ADDENDUM NO. 6

LOXAHATCHEE RIVER DISTRICT

Science Center at Jupiter Inlet Lighthouse Outstanding Area

PROJECT NO. ITB # 22-009-00119

DRAWING NUMBER
DM-1

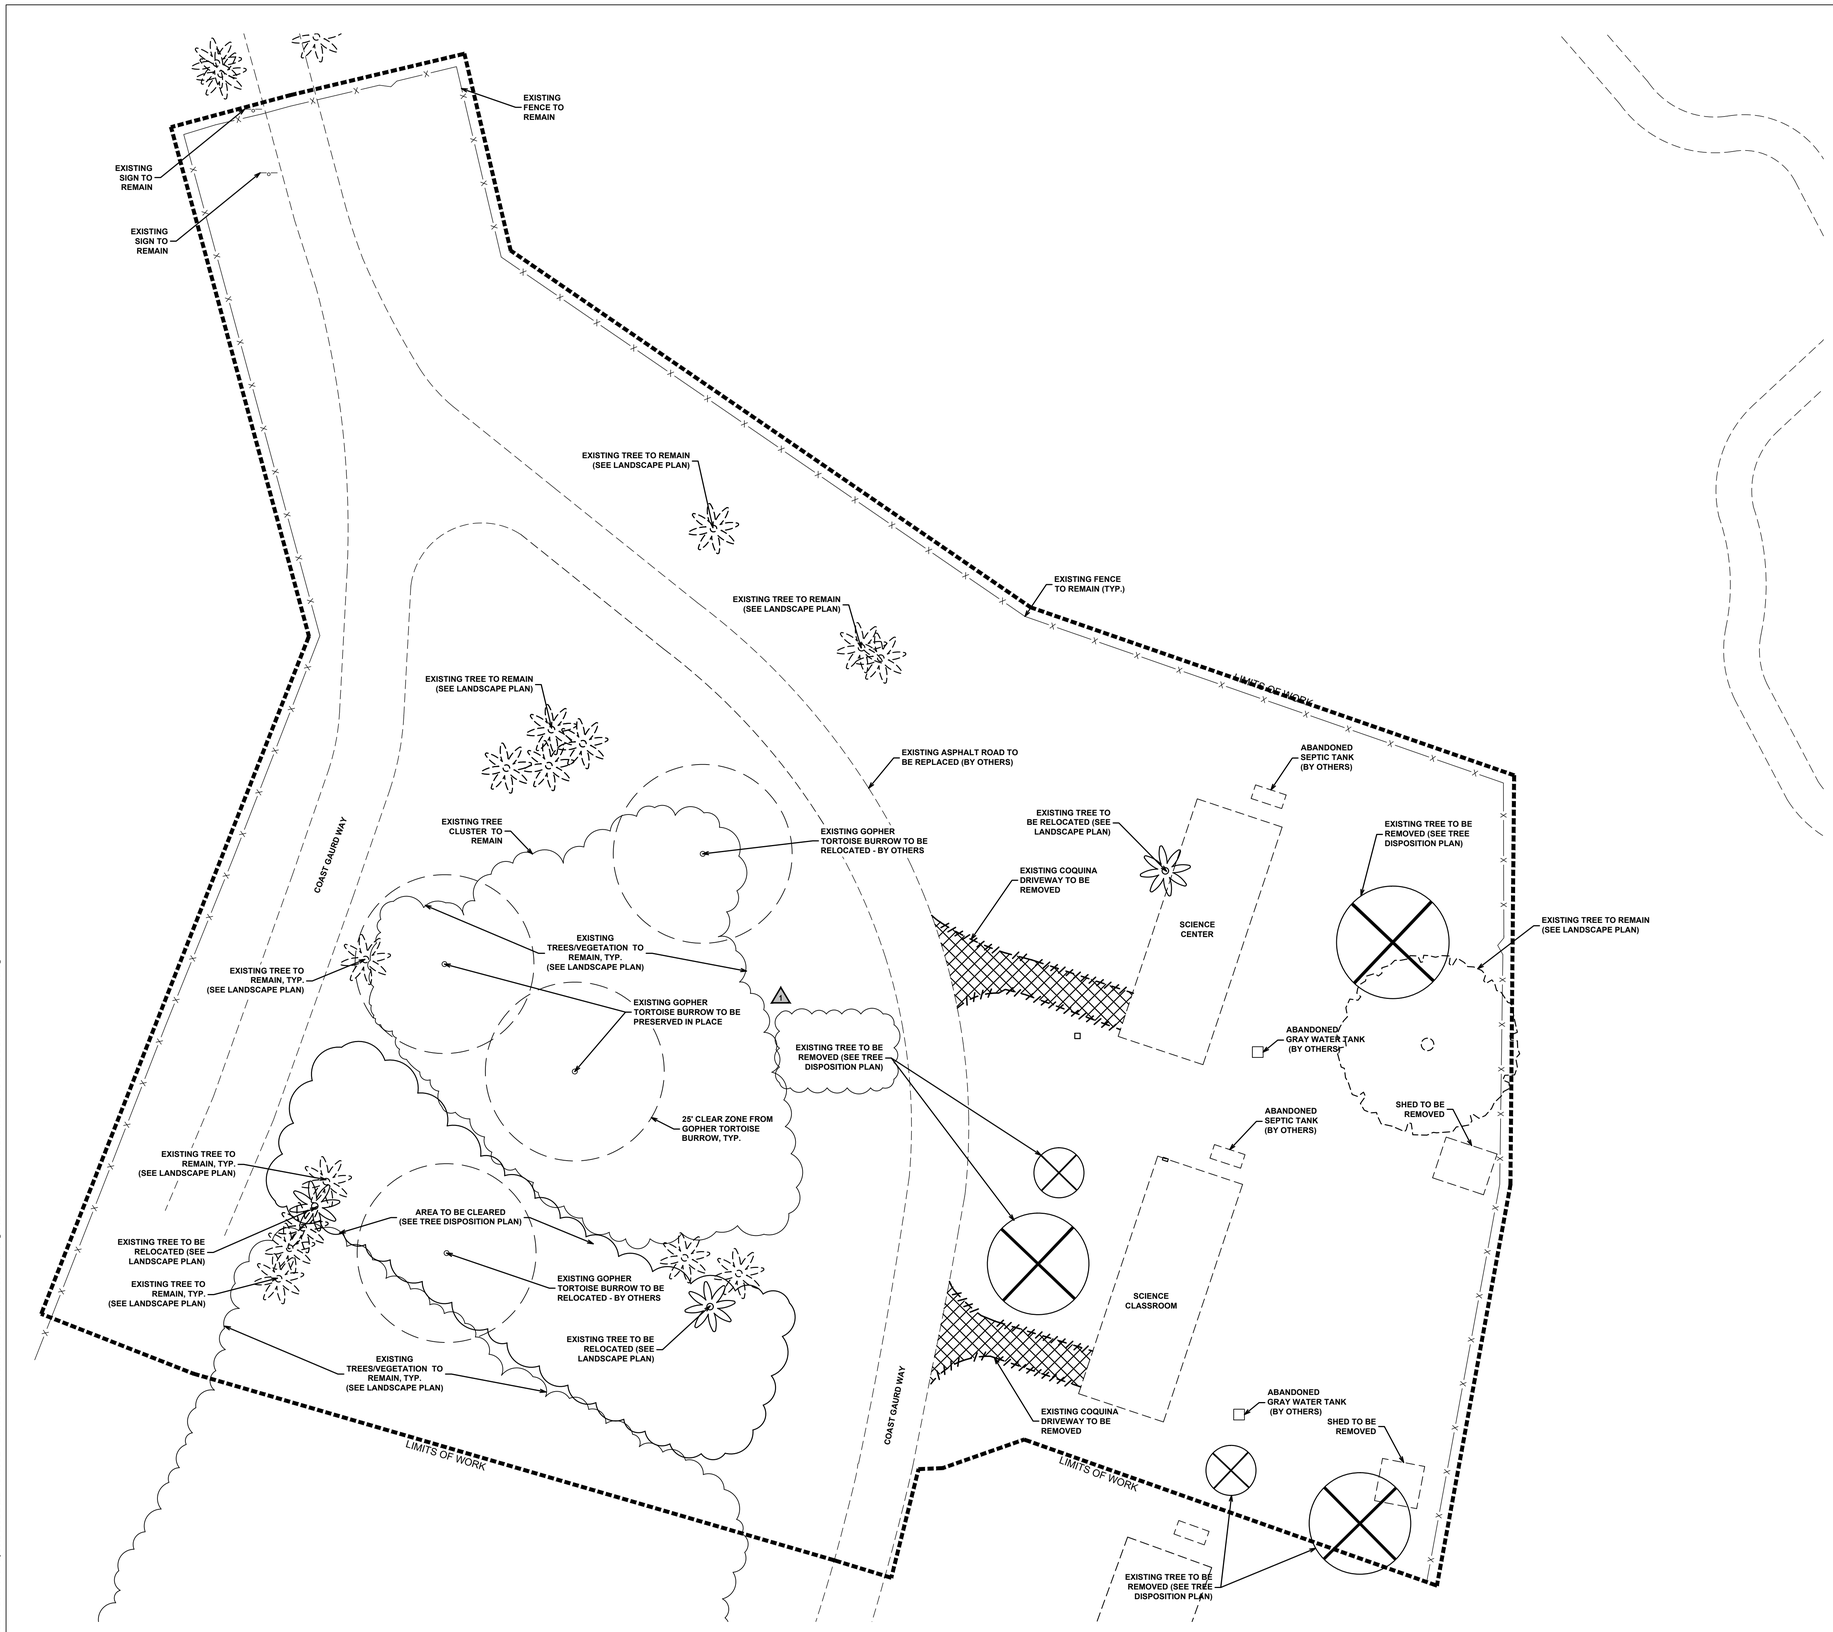
Q14 - Are the two trees in front of the science classroom to remain?
A14 - The existing Queen Palm and the Black Olive in front of the Science Center are both to be removed as indicated in the Tree Disposition Plan. Revised sheet DM-1 is included with this addendum.
Q15 - Plans do not show electrical layout.
A15 - Approximate location of electrical pad and meter are shown in the PGD Plan as existing.

3 PERVIOUS PAVEMENT SECTION

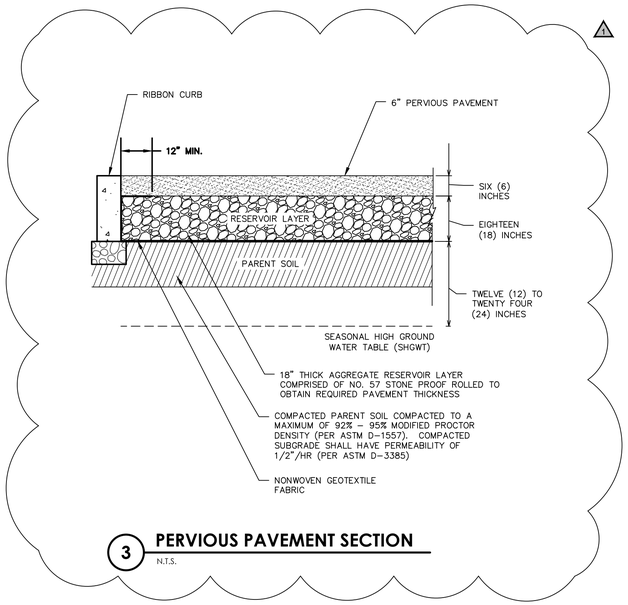
Q13 - On sheet D-1 detail 3 Pervious Pavement Section is says 4,000 psi pervious. There is no ASTM test method for Testing the PSI of pervious. We could probably reach something close to 4,000 PSI by adding more water and consolidating to the point there are no voids.
There are currently no approved test methods from ASTM, ACI, FCPA, ACPA, PCA, or the NRMCA to determine the strength of pervious concrete.
It is generally the Engineering firm that would determine the unit weight of the pervious material and our job to install the material at that unit weight.
Unless you tell me differently, I will bid this in accordance with the latest guidelines from ACI, NRMCA and the FC&PA specifications for Portland Cement Pervious Paving
A13 - Included with this addendum is a revised pervious pavement detail

DRAWING NUMBER
A3.10

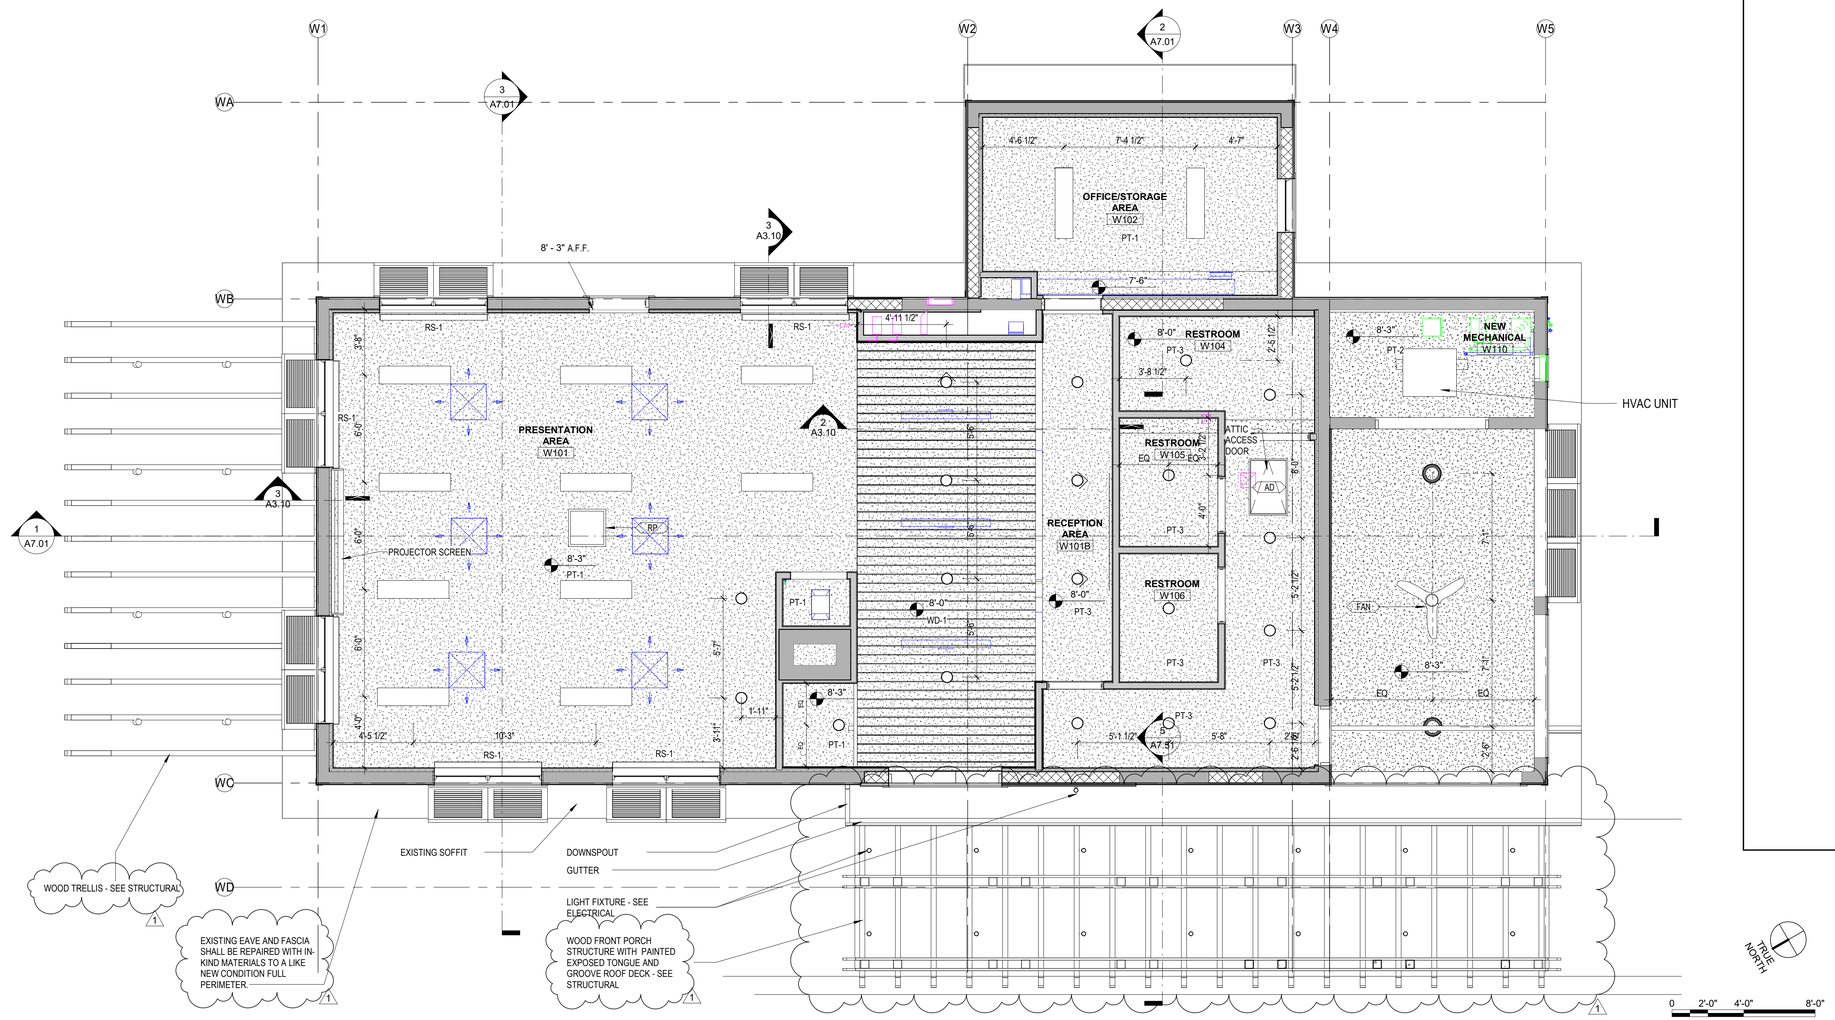
Q7 - The buildings eave and fascia are damaged and should be repaired but the architectural plans do not call for them to be repaired. Please confirm if repairs are part of the project scope
A7 - On both buildings, existing eave and fascia shall be repaired with in-kind materials to a like new condition full perimeter. See revised sheets A3.10 and A3.11.

DRAWING NUMBER
A4.02

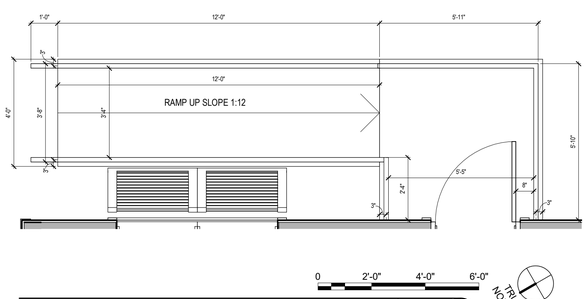
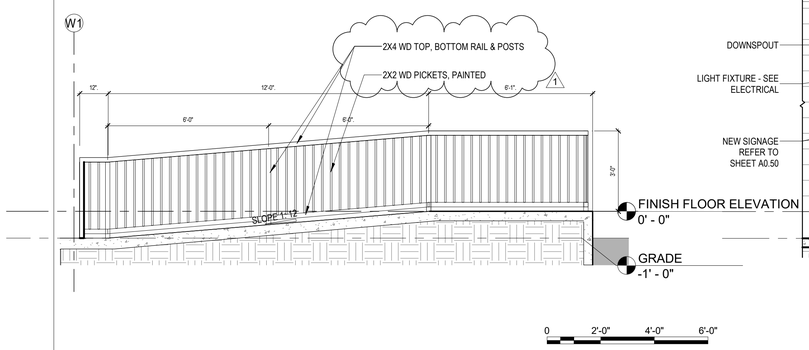
Q22 - Architectural Plans sheet AF 2.10 & and sheet A4.02 shows an exit ramp to be constructed at the east side of the Science building. Structural sheet S 2.01 does not show any structural detail for the ramp construction. Please provide structural detail for this exit ramp?
A22 – Access ramp detail has been included with this Addendum on Sheet S-201 and S-302.

DRAWING NUMBER
E1.01

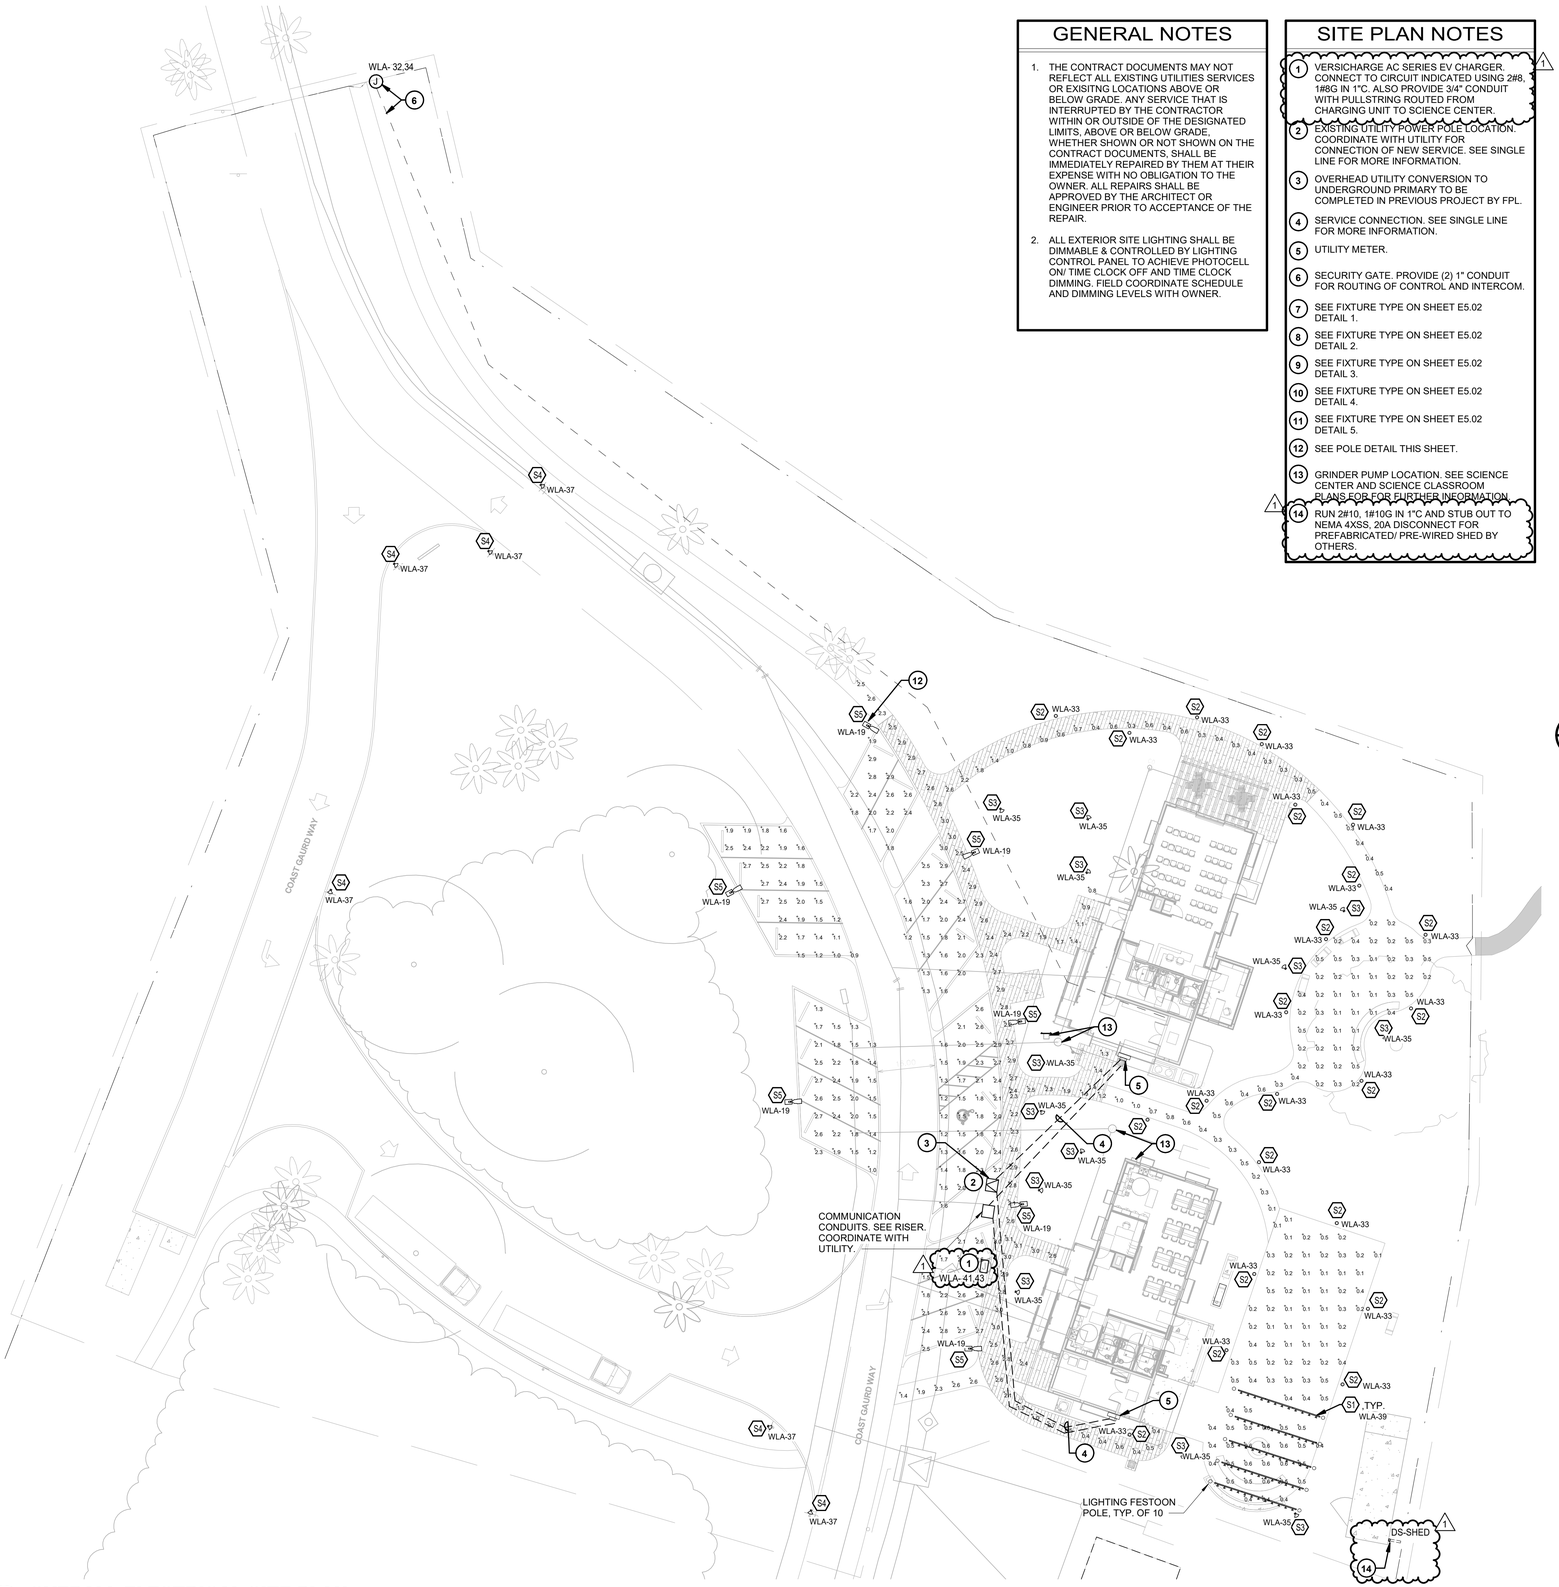
Q3 - As per plan E1.01 note 1, the plan calls for a Siemens Level 2 car charge. The car charger circuit is not noted on any of the panel schedules to confirm which panel it is to be fed from and this sheet does not describe the size of the conduit and wire which due to voltage drop could be required to be upsized. Please confirm.
A3 - Refer to revised electrical sheets issued with Addendum #6.

1. VERSICHARGE AC SERIES EV CHARGER. CONNECT TO CIRCUIT INDICATED USING 2#8, 1#8G IN 1"C. ALSO PROVIDE 3/4" CONDUIT WITH PULLSTRING ROUTED FROM CHARGING UNIT TO SCIENCE CENTER.

14. RUN 2#10, 1#10G IN 1"C AND STUB OUT TO NEMA 4XSS, 20A DISCONNECT FOR PREFABRICATED/ PRE-WIRED SHED BY OTHERS.

DRAWING NUMBER
E2.20

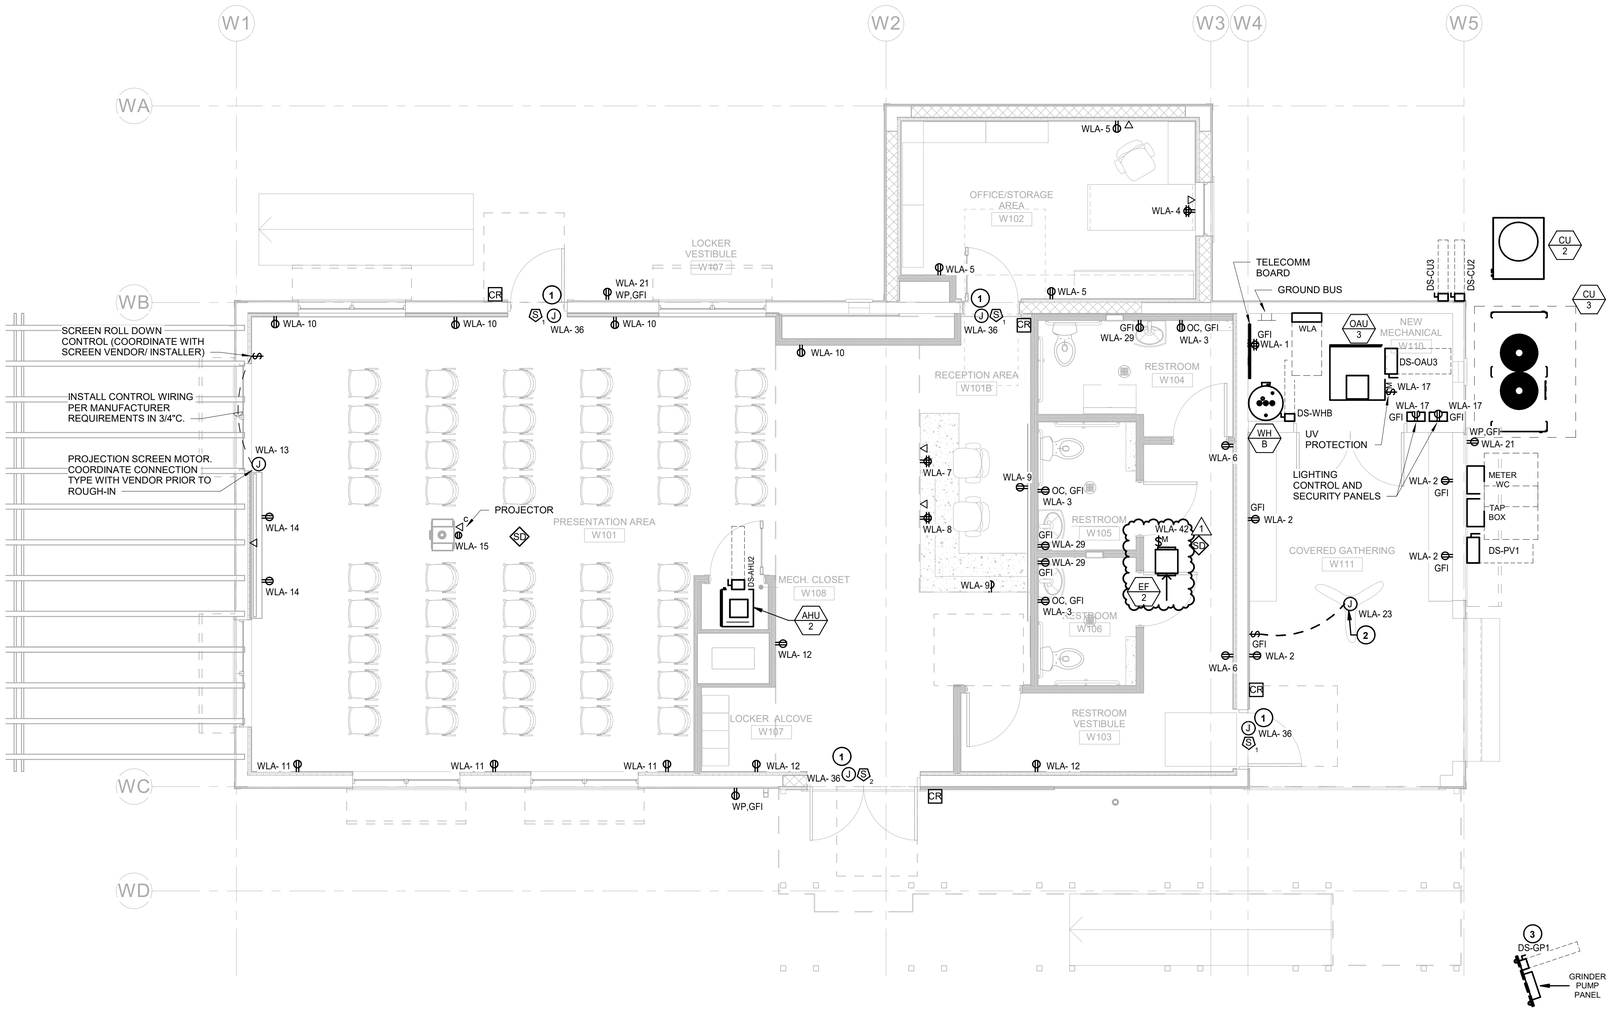
Q4 - As per plan E2.20, the plan shows EF-2 circuit is not noted on any of the panel schedules to confirm which panel it is to be fed from. The size of the motor is provided on the mechanical plans. Please confirm panel.
A4 - Refer to revised electrical sheets issued with Addendum #6.
